CITY OF ALBUQUERQUE

RE: Aviation Center of Excellence Drainage Report
Engineer's Stamp Date: 2/8/17
Hydrology File: M16D024N

Based upon the information provided in your submittal received 2/8/17, the Drainage Report is not approved for Grading Permit. The following comments need to be addressed for approval of the above referenced project:

PROPOSED BASIN MAP
AND DRAINAGE REPORT

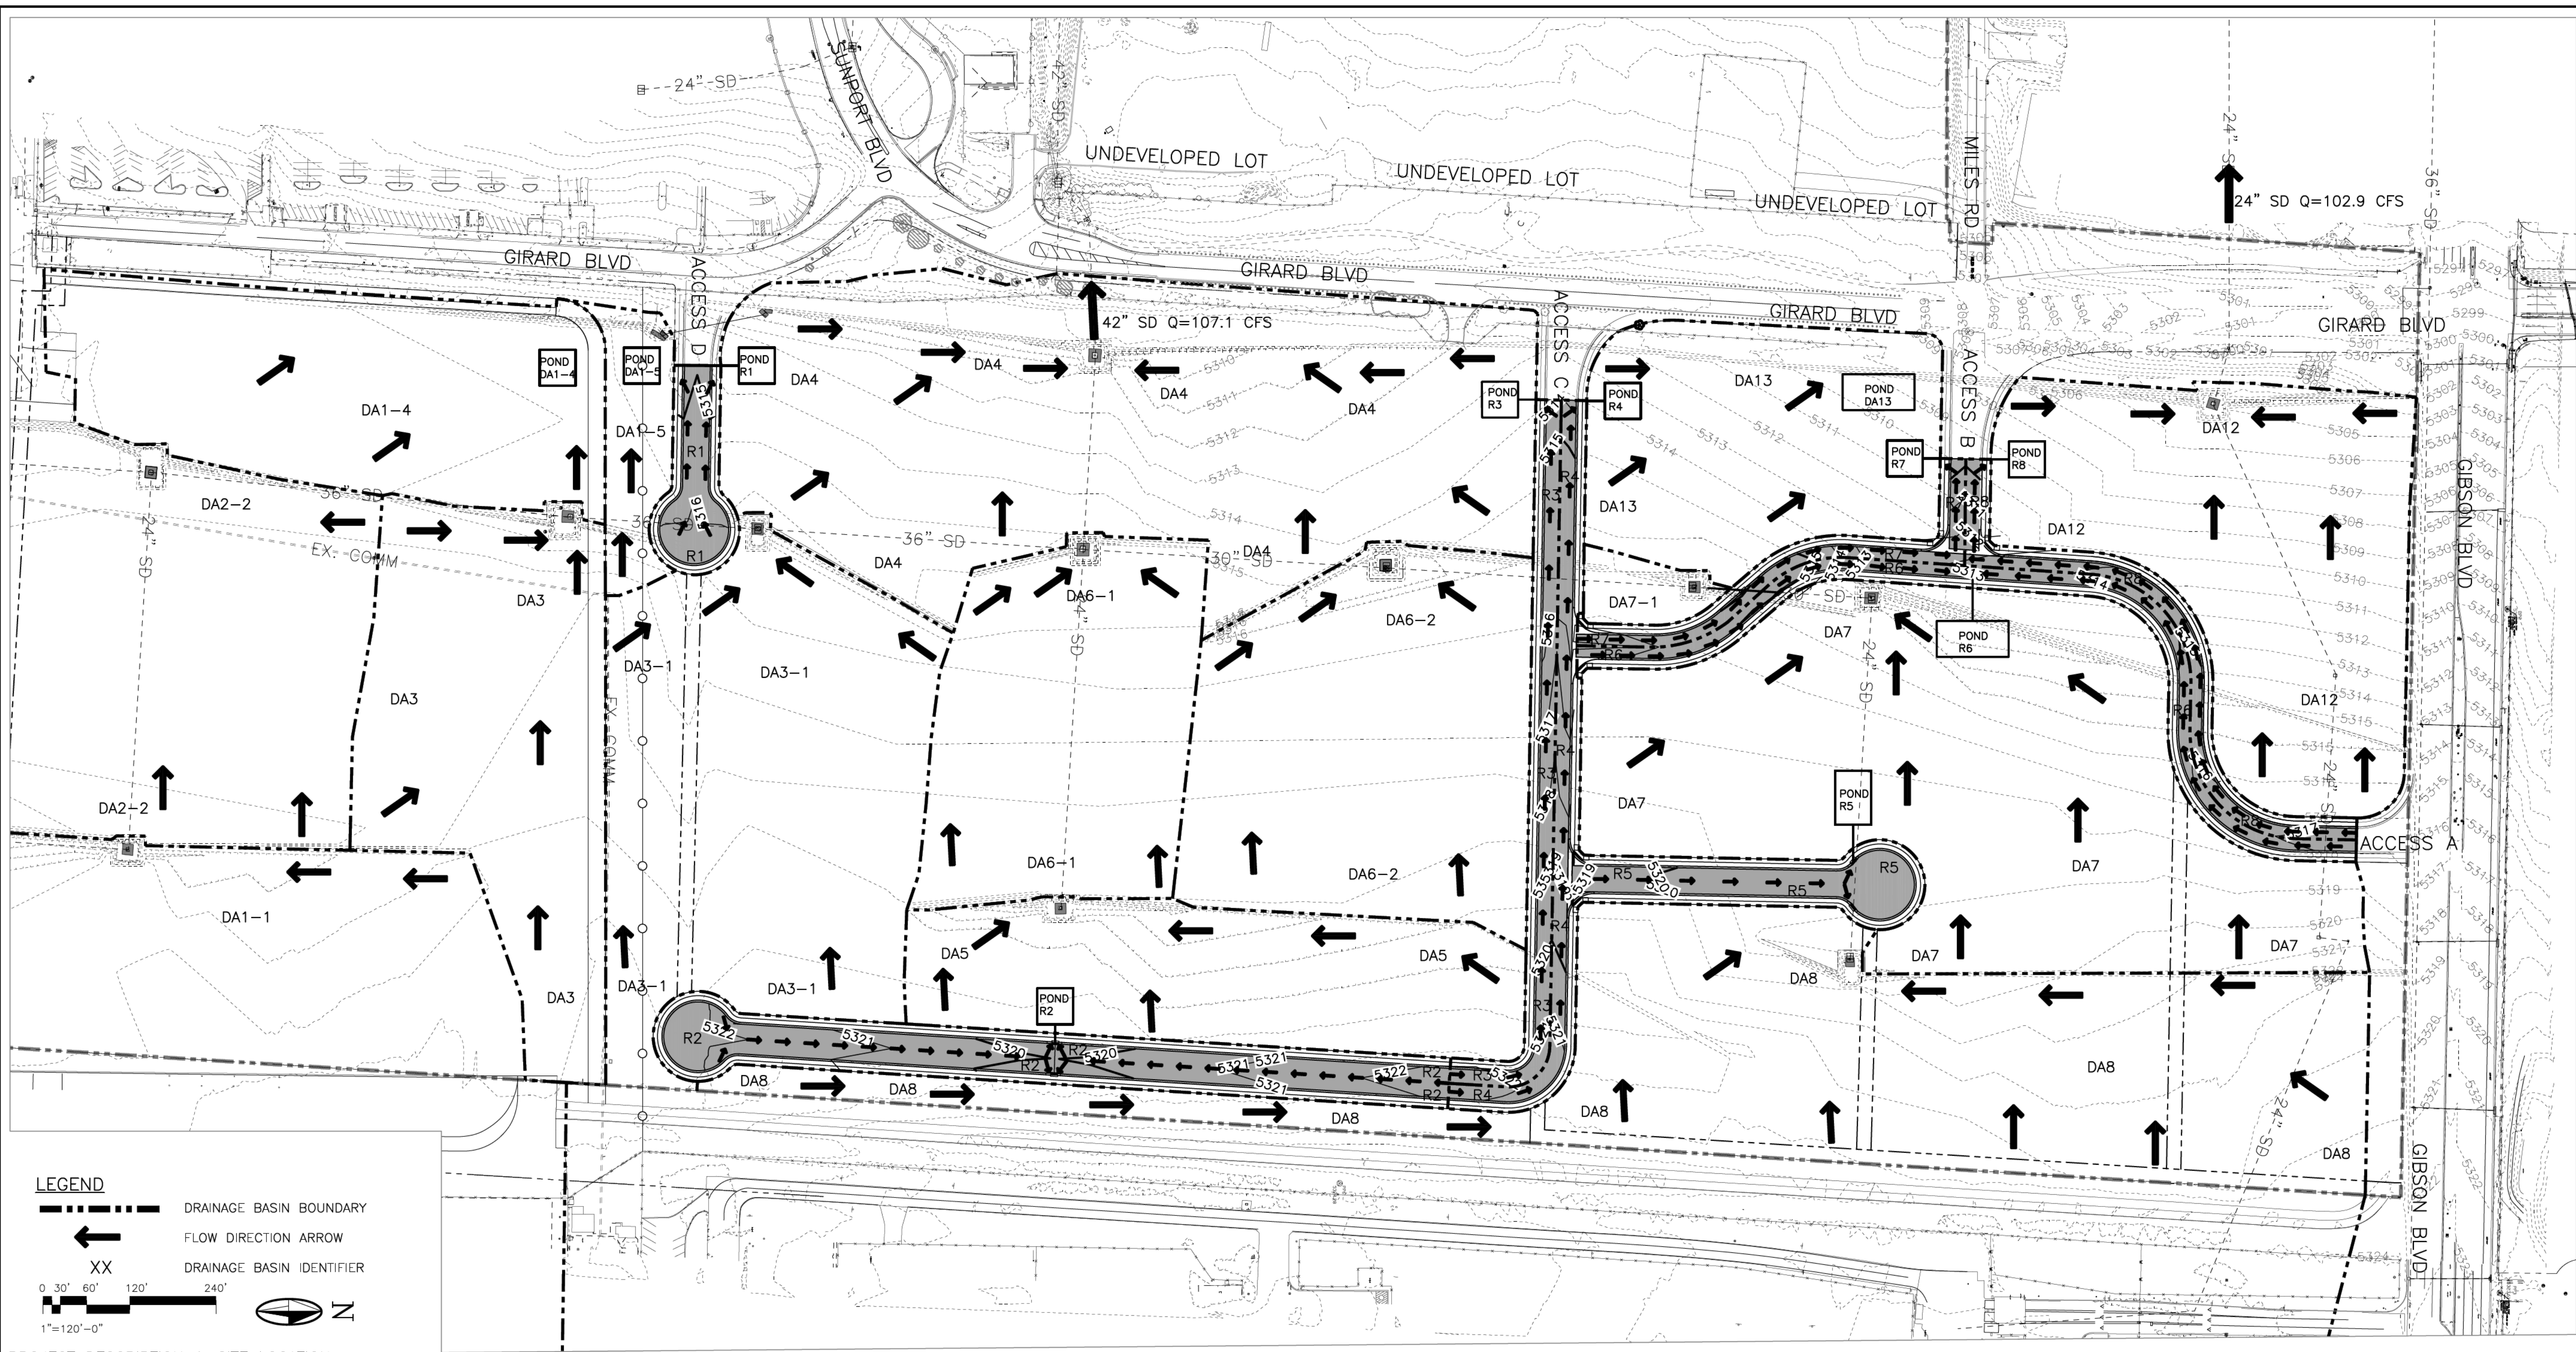
1. The first flush ponds need to be designed as part of these improvements. This information includes pond dimensions, bottom of pond, side slopes, maximum water surface elevation, and pond volume.
2. Waterblocks are necessary where the private roads meet public roads (Girard and Gibson).

It is Hydrology's understanding that these are low-speed, local roads, and the use of dip sections and curb cuts in accordance with standard drawing 2422 is acceptable. If you have any questions, please contact me at 924-3695 or dpeterson@cabq.gov.
